**TOWN OF ADDISON
BUILDING REPORT**

Facility Information: **Facility Name:** Theatre Centre
Facility Contact: Lisa Pyles **Contact Phone:** 972-450-2878

Accessology Inspector Information:
Inspector: Karen Jackson **Date:** April 19, 2017
Email: Kjackson@accessology.com

Latitude: 32.961853 **Longitude:** -96.828709
Address: 15650 Addison Road **City:** Addison **County:** Dallas

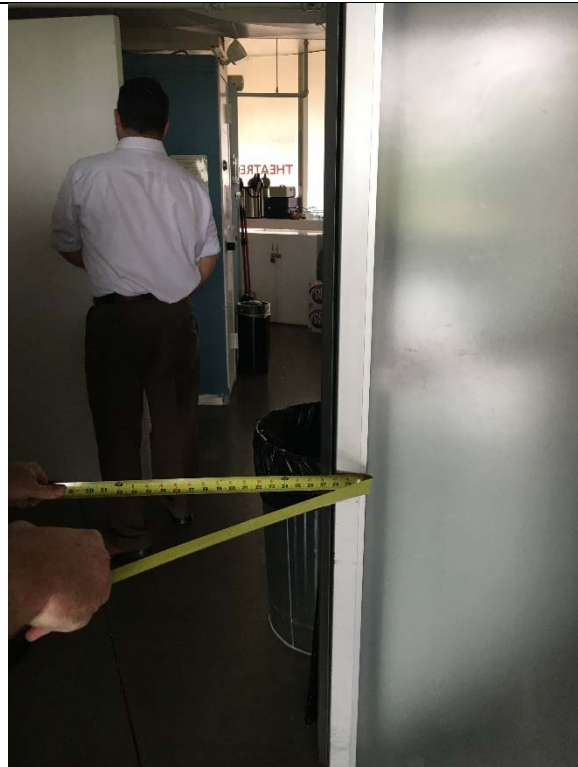
Violation #1: There are no accessible parking spaces provided in the employee parking lot.

In the public parking lot, two of the accessible parking spaces are not a minimum of 96" wide: The third space is 92-1/2" wide and the fifth space is 93" wide.

Violation 1 - There are no accessible parking spaces provided in the employee parking lot.

Violation 2 - Two of the accessible parking spaces are not a minimum of 96" wide: The third space is 92-1/2" wide and the fifth space is 93" wide.

Add two (2) accessible parking spaces, one being van accessible with an access aisle and compliant signage.

Restripe spaces to achieve a minimum of 96" wide car parking spaces while maintaining the 11' wide van accessible space.

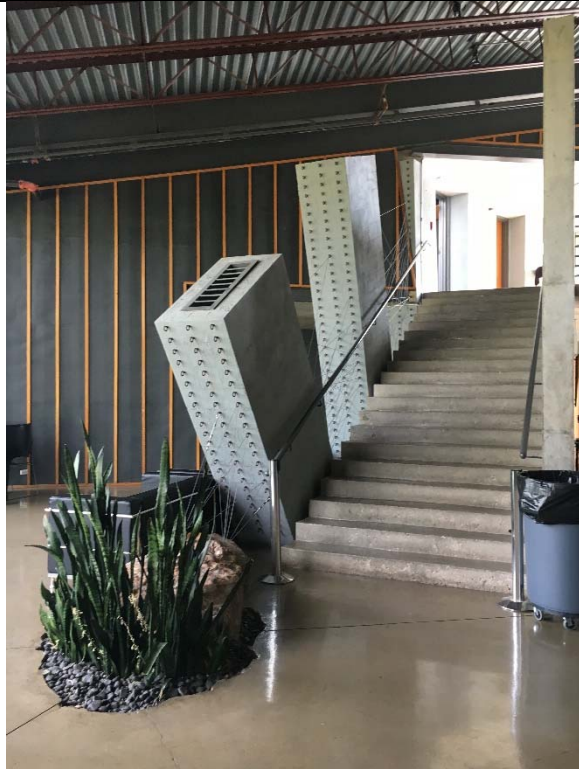
There are approximately 35 doors throughout the facility that have door knob hardware requiring grasping and twisting to operate.

Access into the ticket booth is only 28" wide where 32" minimum is required.

Violation 3 - There are approximately 35 doors throughout the facility that have door knob style hardware requiring grasping and twisting to operate.

Violation 4 - Access into the ticket booth is only 28" wide.

Replace all existing knob hardware with lever type hardware.

Modify door into ticket booth to provide 32" minimum clear width.

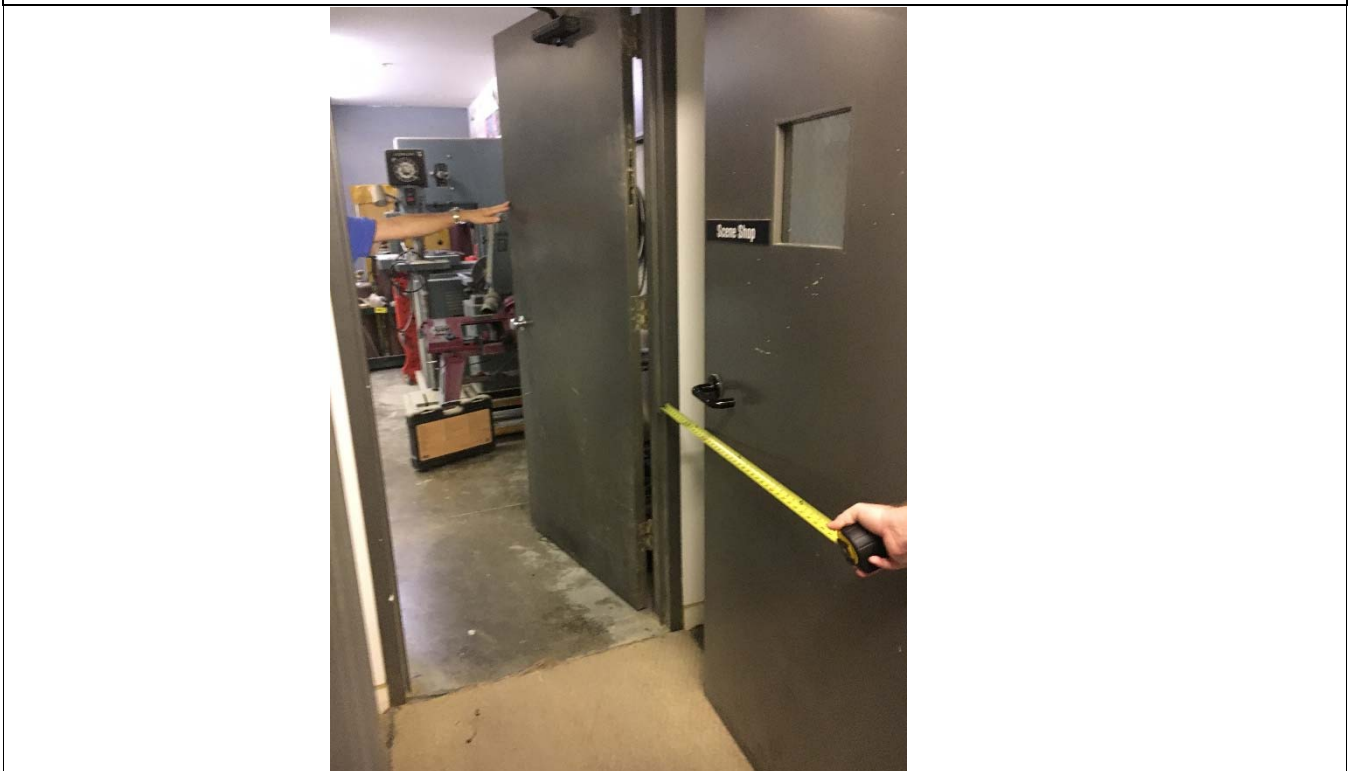
The concessions stand counter is at 45" above finished floor to the counter.

There is no accessible route to the 2nd floor of the building.

Violation 5 - The concessions stand counter is at 45" above finished floor to the counter.

Violation 6 - There is no accessible route to the 2nd floor of the building.

Modify counter to provide a 36" high and 36" long portion.

Install an elevator to provide access to the amenities on the 2nd floor.

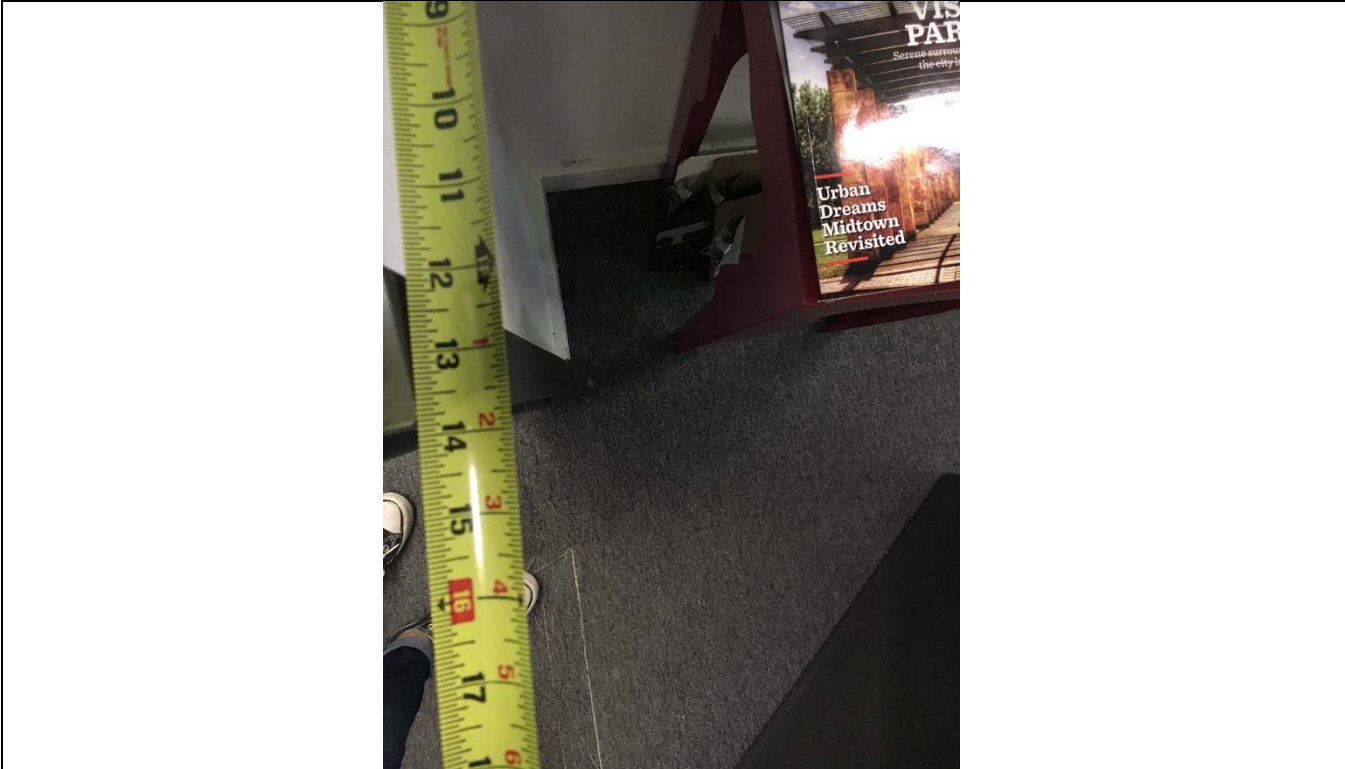
There are approximately 15 permanent signs throughout the building that are mounted in the incorrect location and do not have Braille or tactile characters.

The scene shop has 2 doors in a series with only 13-1/2" between doors.

Violation 7 - There are approximately 15 permanent signs throughout the building that are not compliant.

Violation 8 -The scene shop has 2 doors in a series with only 13-1/2" between doors.

Replace with compliant signage on the hinge side of the doors.

Remove one of the doors to alleviate doors in series condition.

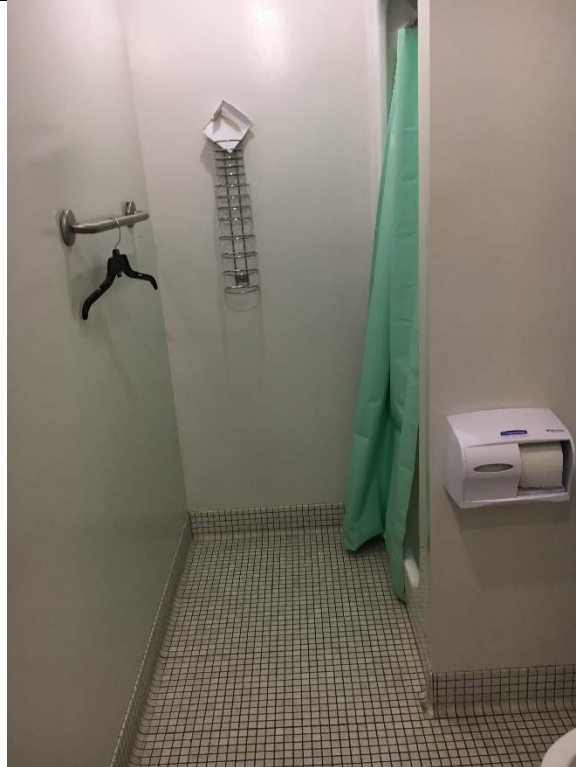
Multiple doors throughout the Theatre (3 offices, board room, crew restroom, Theatre staff only area and the scene shop) do not have the minimum 18" maneuvering clearance on the pull side.

Violation 9 - Multiple doors throughout the theater (3 offices, board room, crew restroom, theater staff only area and the scene shop) do not have the minimum 18" maneuvering clearance on the pull side.

Modify doors to provide 18" minimum clearance.

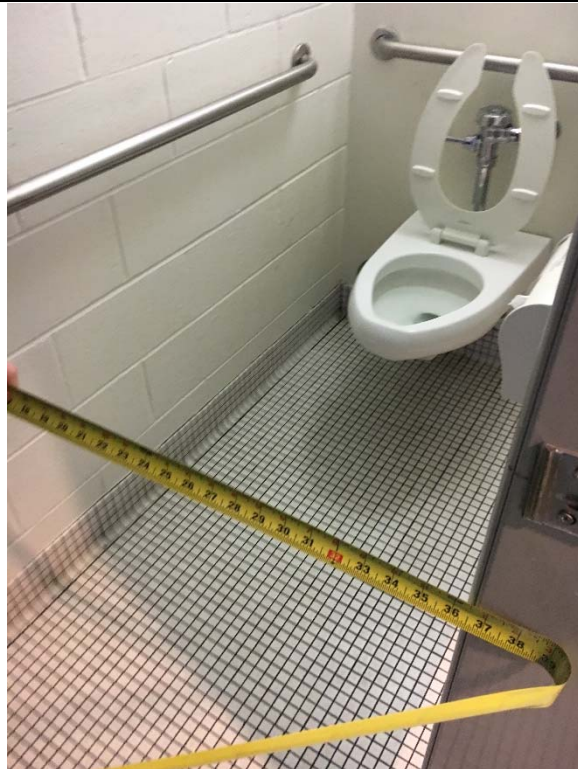
The crew shower room is too small and is has no compliant fixtures.

Violation 10 - The crew shower room is too small and is not fully compliant.

Modify room to provide accessible water closet, shower stall, lavatory and dispensers.

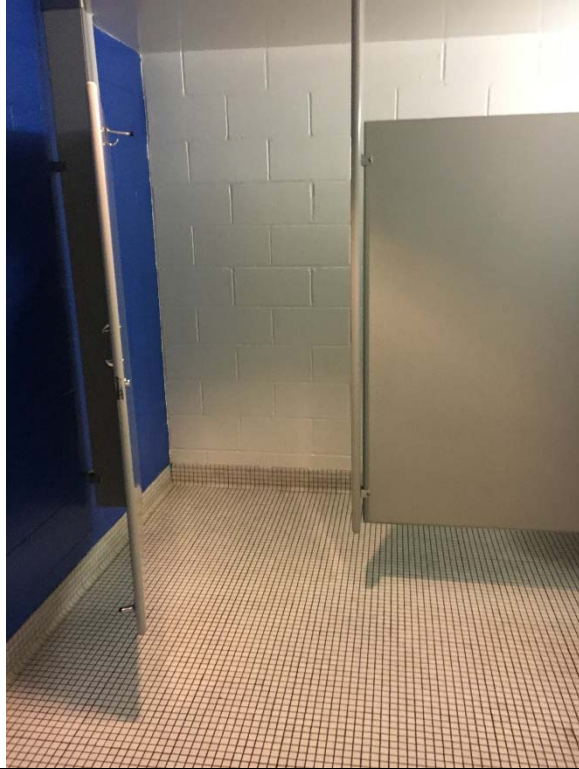
Dressing room #5 is noted to be the accessible dressing room. There is a restroom with a shower provided that is too small and is not fully accessible.

Men's Restroom - Accessible stall is only 36.5" wide.

Violation 11 - Dressing room #5 is noted to be the accessible dressing room. There is a restroom with a shower provided that is too small and is not fully accessible.

Violation 12 - Men's Restroom - Accessible stall is only 36.5" wide.

Modify dressing room to provide fully accessible restroom/shower facilities.

Modify restroom to provide an fully accessible stall.

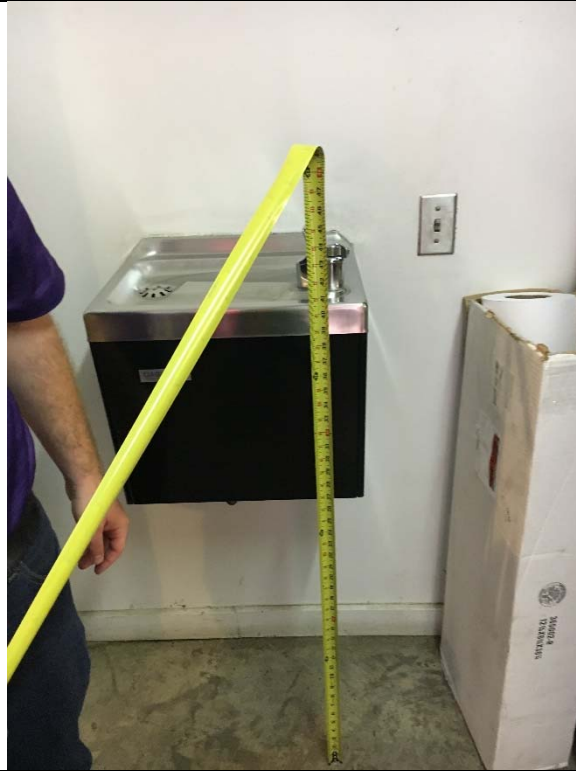
Men's Room - Stall door is not self-closing.

Men's Room - Flush control is on the closed side of the stall.

Men's Restroom - Coat hook is mounted at 66.5" above finished floor.

Violation 13 - Men's Room - Stall door is not self-closing.

Violation 14 - Men's Room - Flush control is on the closed side of the stall.

Violation 15 - Men's Restroom - Coat hook is mounted at 66.5" above finished floor.

Install a self-closing mechanism on the stall door.

Replace flush valve to the open side of the water closet.

Install a coat hook that is no higher than 48" above finished floor.
